TECHNICAL BULLETIN

| SUBJECT:	TECHNICAL BULLETIN: 18-11
VERSASAFE X3	DATE: AUGUST 29, 2018

OPTIONAL UPGRADE – VERSASAFE X3

VersaSafe touch screen display

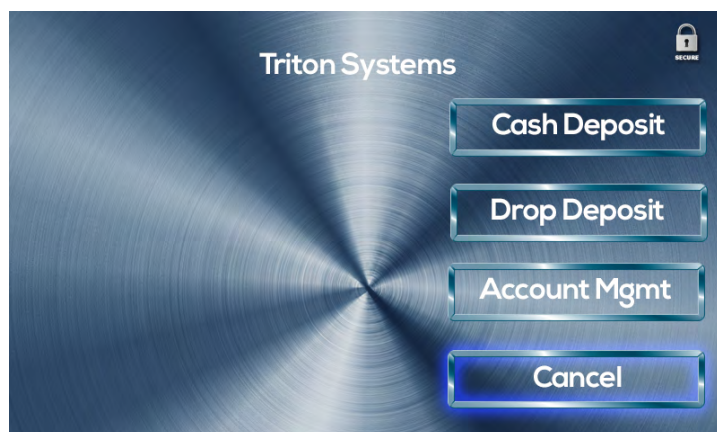
The new VersaSafe X3 is equipped with a 7" touch screen display and new control panel, an updated component tray and new cabling, and an additional bill validator option. The new option features up to two bill acceptors with locking 600 note cassettes that can be fitted with bulk note feeders, if desired. Contact Triton Sales for availability.
